DOMINION RIDGE PARK
Preliminary Overall Area Development Plan

Re: Dominion Ridge Park

POADP # 711

The City Staff Development Review Committee has reviewed Dominion Ridge Park Subdivision Master Development Plan M.D.P. (formally POADP) # 711. Please find enclosed a signed copy for your files. Your plan was accepted however please note the following:

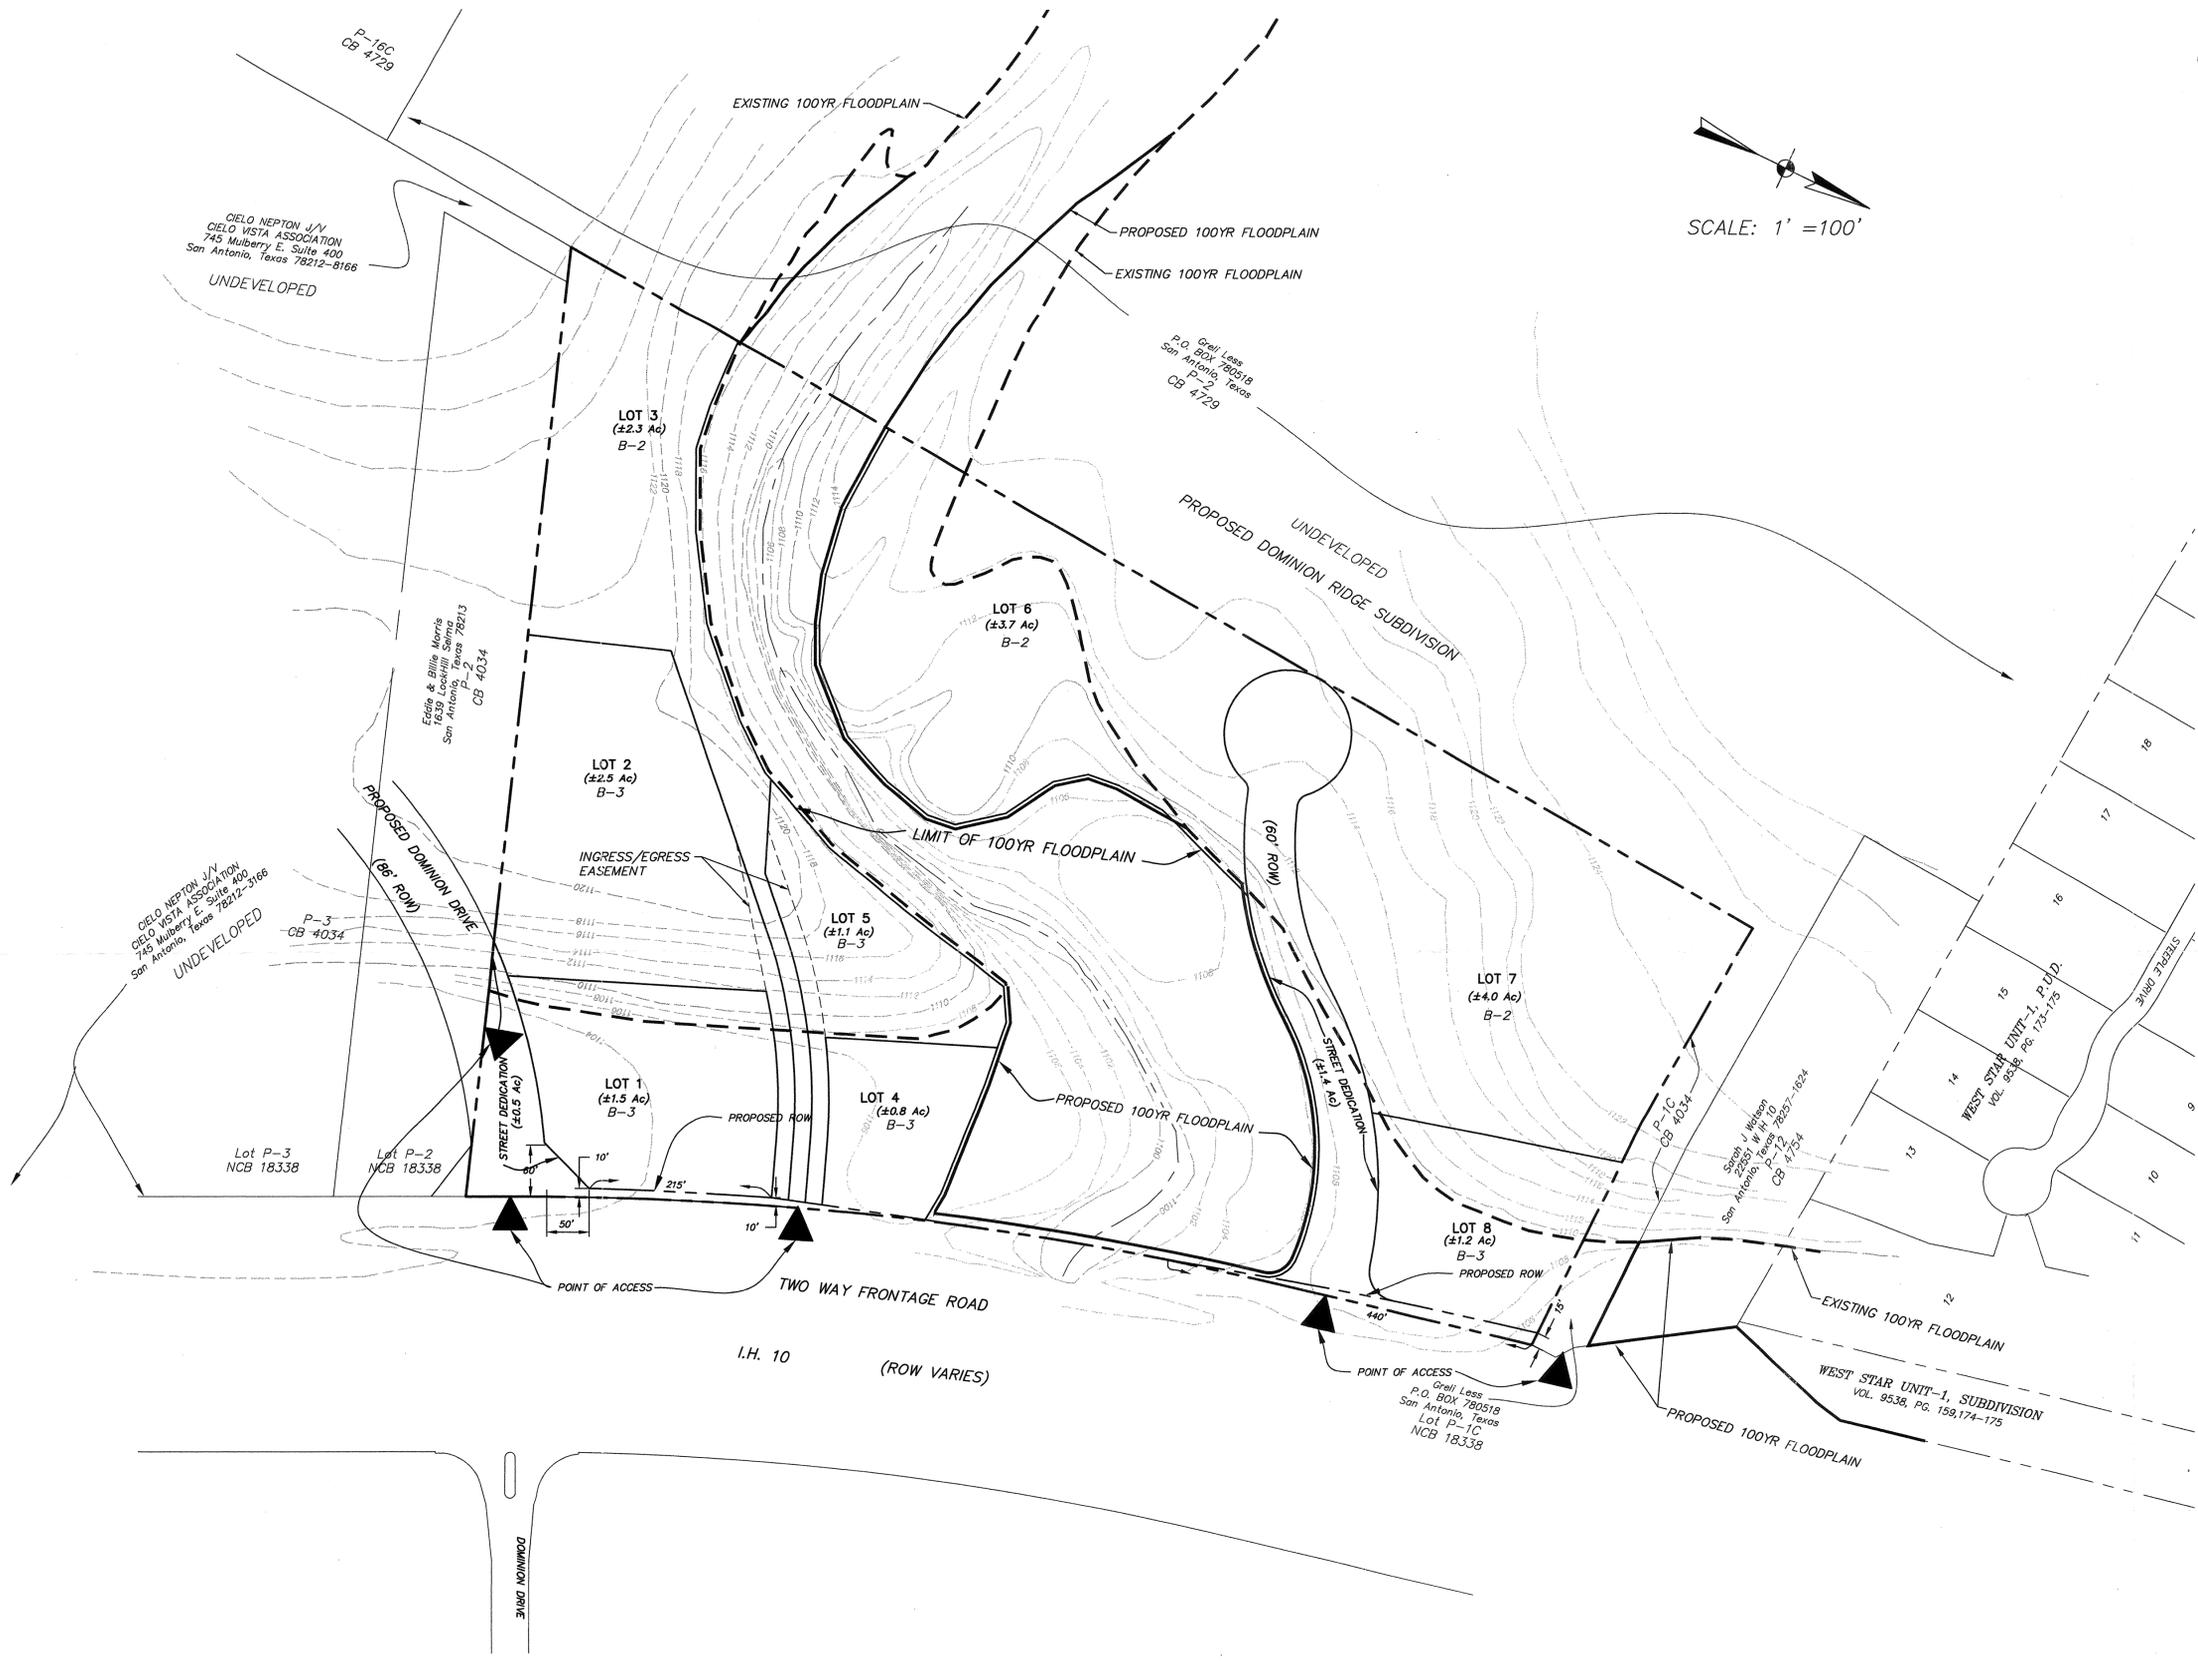
- In consideration of public safety and convenience, excessive grades by reason of topography should be avoided in street layouts and arrangements.
- Any access and R.O.W. issues along state facilities will need to be resolved with the Texas Department of Transportation (TXDOT). For information about these requirements you can contact TXDOT at 615-5814.
- This development will need to comply with tree preservation ordinance #85262. For information about these requirements you can contact Building Inspections at 207-7102.
- It will be expected that you will plat all of the property depicted in your Master Development Plan (M.D.P.) (formally POADP), to include floodplains, drainage areas and open space.
- I would encourage you to work closely with the school district, so that they can plan accordingly.
